August 23, 2001

SUBJECT: TECHNICAL ASSISTANCE REQUEST - REVIEW OF GROUNDWATER
TEST RESULTS SUBMITTED BY VIRGINIA POWER CO. FOR ITS
CATEGORY I SERVICE WATER POND DAM AT NORTH ANNA

Project: Dam Safety Inspection - North Anna Category I Service Water Pond Geochemistry

FIGURE 1
 PLAN-CURRENT INSTRUMENTATION
 SERVICE WATER RESERVOIR
 NORTH ANNA POWER STATION

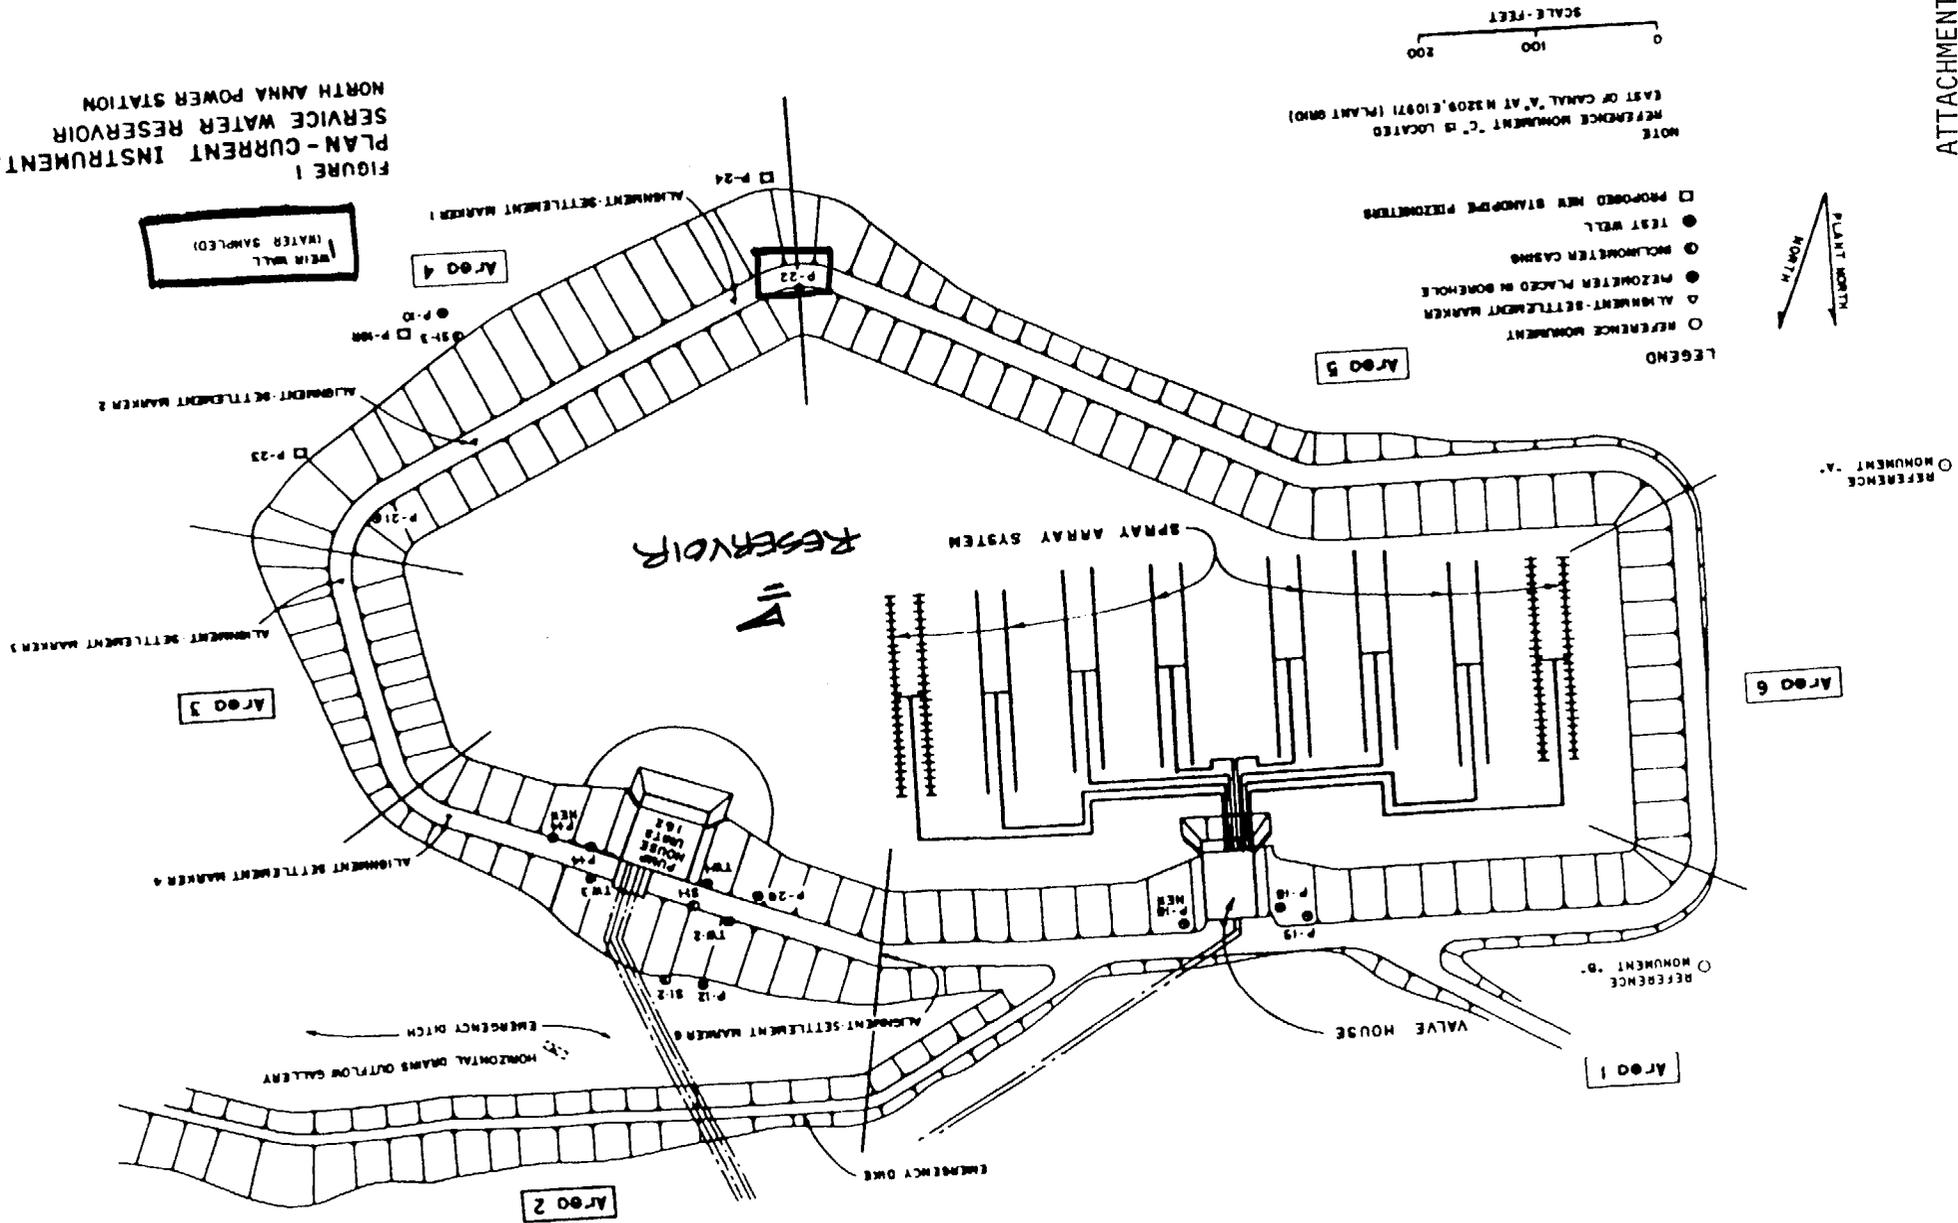
Requested Action: Reviewer shall determine if information submitted by Virginia Power Co. (VPC) is sufficient to determine if impounded water can be related chemically to water from piezometer P-22 and/or surface water from a wet area below the SWR dike. If licensee-provided information is insufficient, reviewer shall provide written recommendations for appropriate testing to make such determination. If the information provided is sufficient, then reviewer shall make a written opinion regarding any relationship of the water from the three sources.

Background: In 1997, 1999, and 2001, NRC has observed apparent seepage water below the SWR embankment. VPC has stated that the water is runoff, unrelated to seepage. On January 12, 1998, VPC took water samples from the SWR, piezometer P-22, and ponded water below the SWR dike. VPC ran conductivity tests and concluded that the water from P-22 and below the SWR dike did not originate from the reservoir. A technical review of the test results and conclusions is requested.

Action: Water samples were taken from three areas around the SWR on January 12, 1998 to measure conductivity. These included water from the service water reservoir, water from piezometer P-22 casing during bailing, and ponded water at the weir wall in the wet area below the SWR dike and adjacent roadway (Attachment 2, Figure 1).

Piezometer P-22	99 micromhos
Weir Wall	123 micromhos
Service Water Reservoir	922 micromhos

These conductivity tests clearly indicate the water obtained from piezometer P-22 and the drainage area did not originate from the reservoir and therefore are not the result of seepage from the reservoir. As a comparison, the conductivity of distilled (de-ionized) water ranges from 0.05 to 2.0 micromhos.

Action: Results of the conductivity tests on a water sample taken from the weir wall which is located downstream or downgradient from the other weirs, clearly indicates that the water did not emanate from the reservoir. Therefore, reactivating weir flow measurements would only measure runoff and groundwater movement which would provide extraneous data not pertaining to SWR seepage or stability. In our opinion, such effort is unwarranted.
